④	.	Revision	00	Item	EPT-42Q0AN(H1)		
③	.	Drawn	JH KIM	Title	OSD BOARD		
②	.	Design	JH KIM	Dwg	.		
①	.	Check	..	No. Sheet	1 of 1	Date	05.11.25
①	최초작성	Approve	JS PARK	No.	E-RAE ELECTRONICS INDUSTRY CO.,LTD

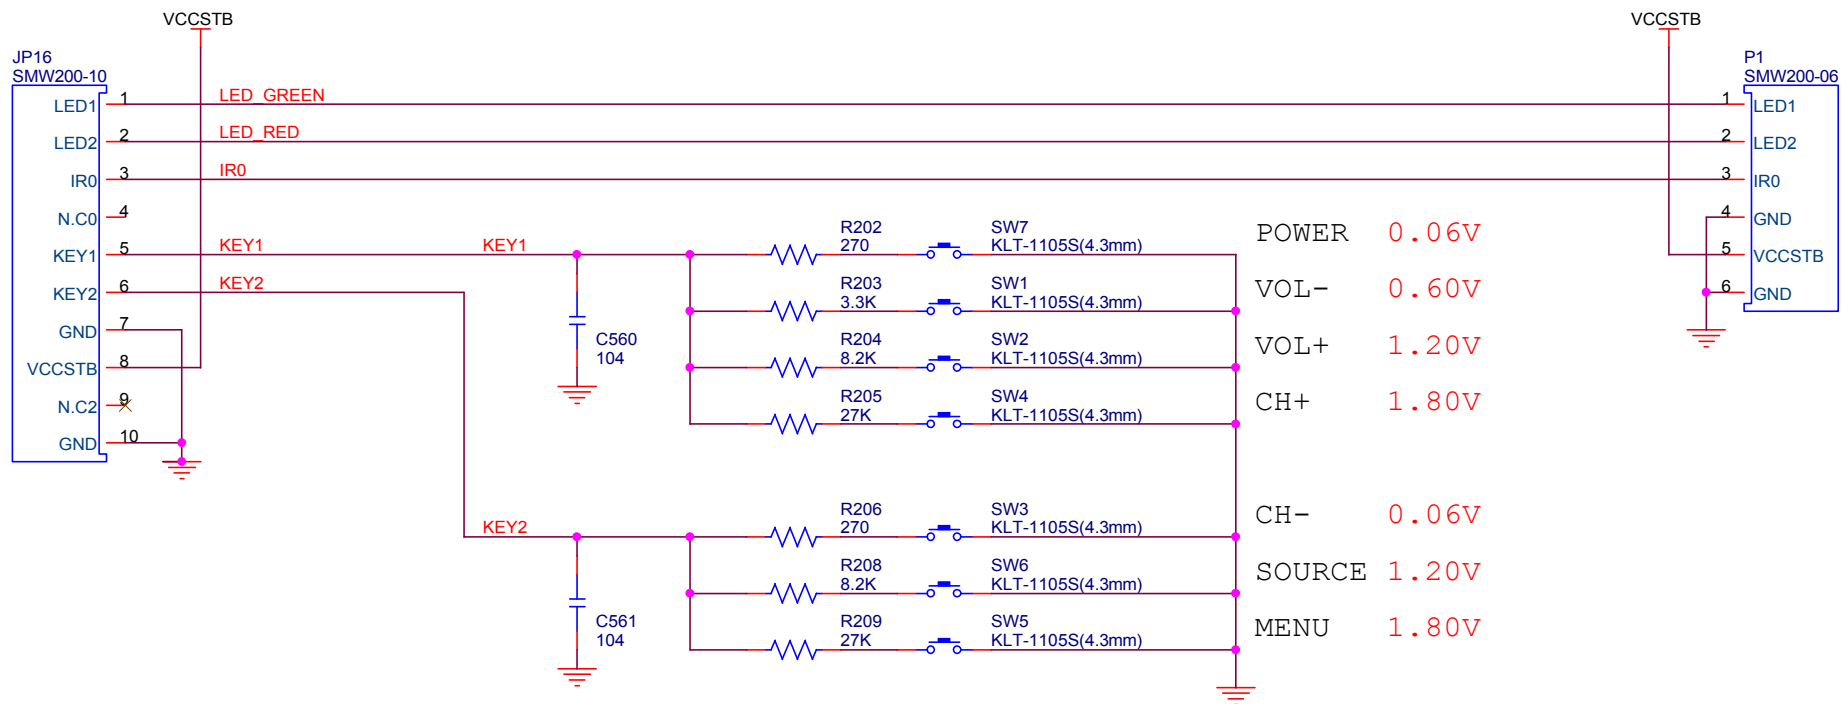
LOC.	Before		After	
R202	270	0,06V	270	0,06V
R203	5,1K	0,85V	3,3K	0,60V
R204	27K	1,8V	8,2K	1,20V
R205	100K	2,29V	27K	1,80V
R206	270	0,06V	270	0,06V
R208	27K	1,80V	8,2K	1,80V
R209	100K	2,29V	27K	2,29V
